ADDENDUM NO. 1- COWARD BALL FIELDS (BID NO. 32-14/15)

COWARD BALL FIELDS

Coward, SC

ALTERNATE 1

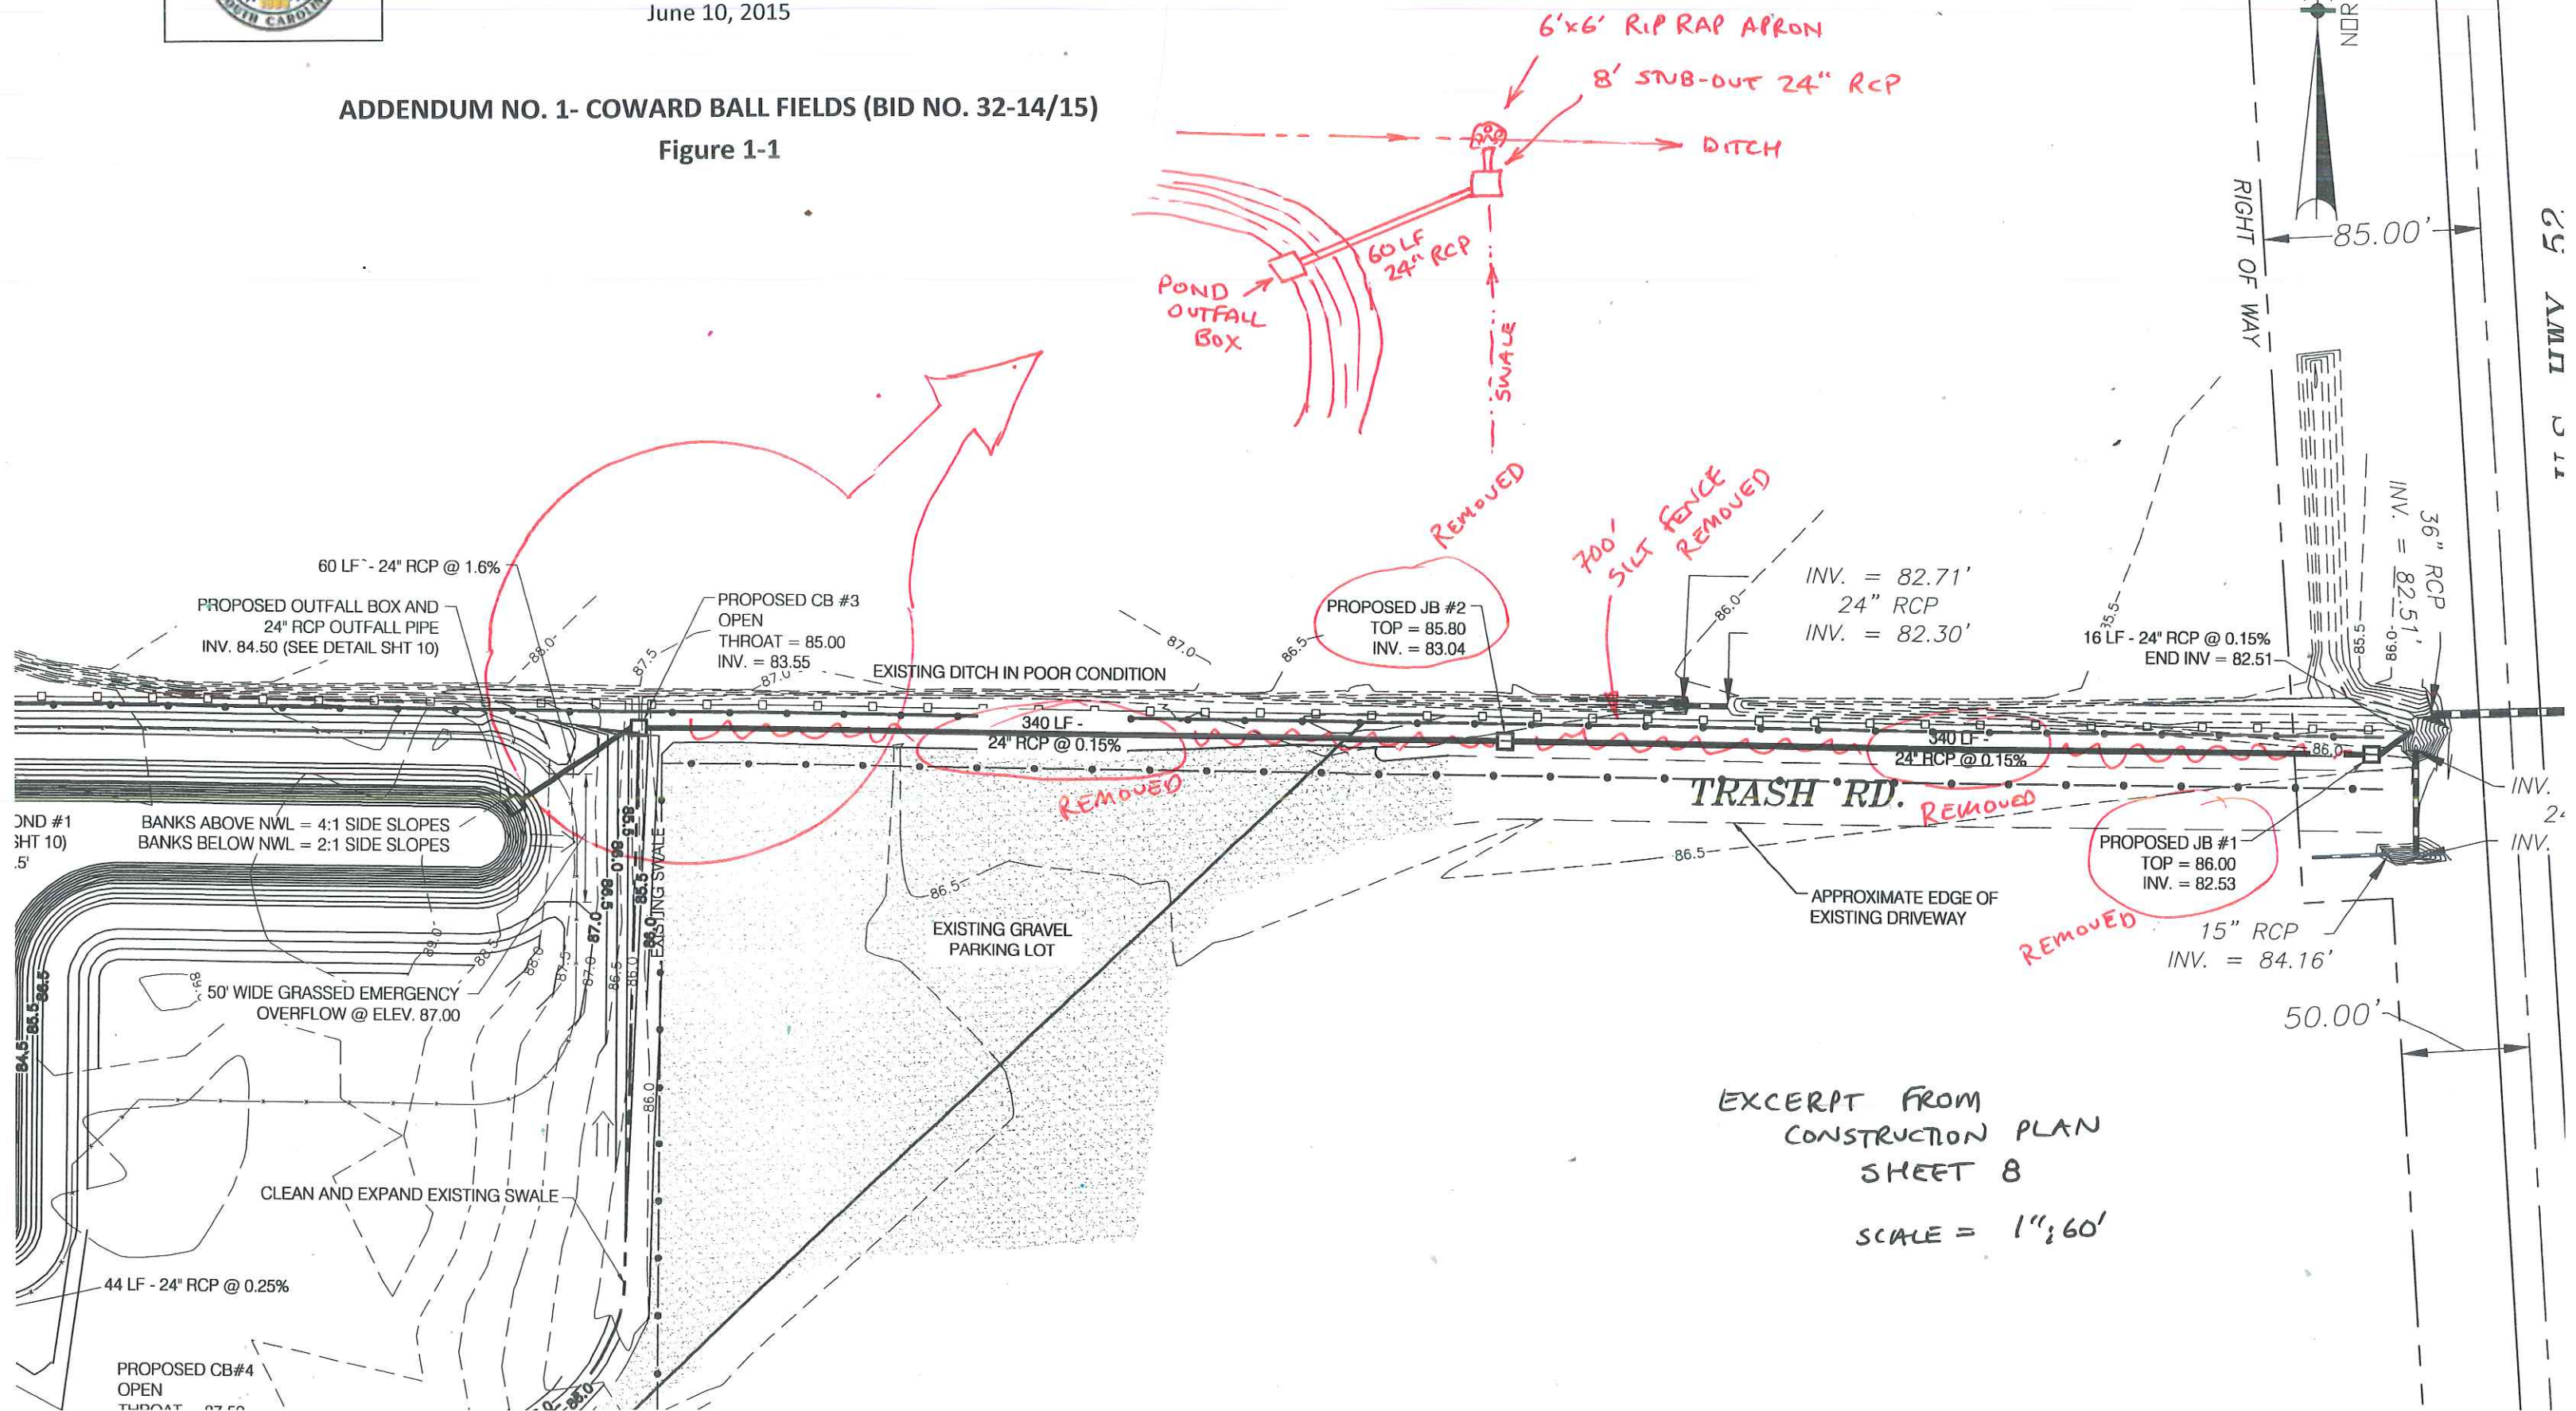
6. How does the County intend to construct the infields? The County has requested that the Contractor cut the infields down to subgrade (assuming that the County will add 4 to 6 inches of sand clay) and leave it ungrassed. This is for both Field #1 and Field #2, see attached Figure 1-2. The infield areas are marked in red, they total 2100 cubic yards. This is accounted for in the updated Bid Sheet.
7. Alternate #1: Figure #1-3 shows an alternate for placing 1-1/2" PVC pipe in the ground for irrigation purposes. The pipe will have 24" of cover and run from the edge of the gravel parking lot to the center of the ball fields. The purpose is for temporary irrigation, though the pipe would remain in place to help with irrigation on the future ball fields as well. The line would have stub-outs as shown, each would be 1" diameter and have a 1" gate valve closure.

The east end would stub out near the location shown. The County may negotiate a deal with the City of Coward to tie into that line with City water, otherwise the line would be used to pump water from the pond and reduce the movement of hoses across the new fields.

Alternate #1 involves installation, materials, and testing of the PVC pipe. Tapping, meters and backflow prevention will be handled by the County if they decide to tie the line into City water.

○ APPROXIMATE STUB-OUT LOCATIONS:
1 1/2" TEE W/ BUSHING TO 1" PVC
1" GATE VALVE & CAP

Figure 1-1

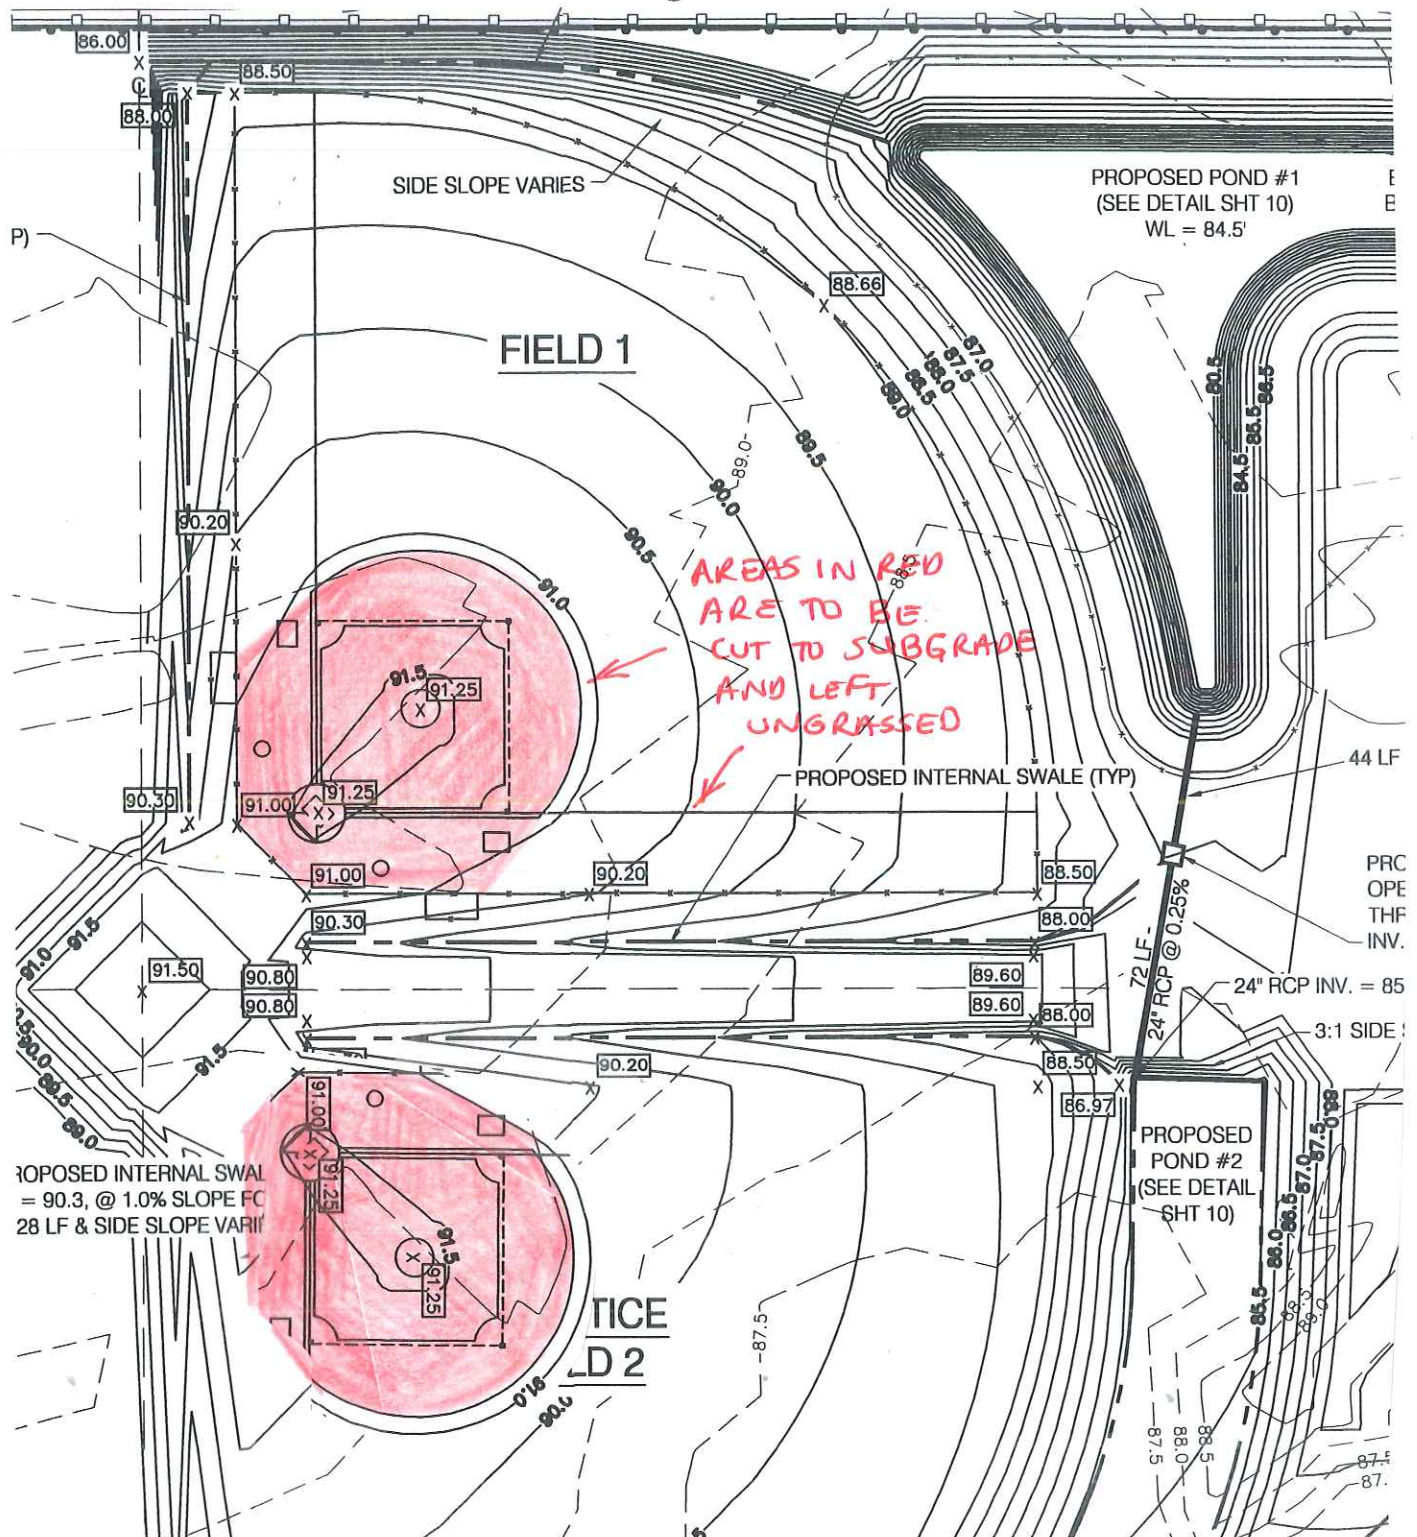
4. Where are the bid quantities on page 2 of the Bid Sheet? An updated Page 2 is attached; it includes the bid quantities.
5. There is a discrepancy between the drawings and the amount of 24" RCP shown on page 2 of the Bid Sheet. On Sheet 8 (the Grading & Drainage Plan) there is a stretch of 24" RCP along Trash Road. It parallels the ditch for 696 feet and connects the pond outfall at CB#3 directly to US Highway 52.

This RCP has been value engineered out of the project and is not part of the bid. 688 feet of this pipe, as well as JB#1 and JB#2, do not appear on the Bid Sheet quantities and will not be installed. Likewise, 700 feet of silt fence has been removed.

The 24" RCP will leave CB#3 and go directly to the ditch (see Figure 1-1, attached). Please note that the rip rap apron at the end of the pipe at Hwy 52 will be moved to the new end-of-pipe in the ditch.
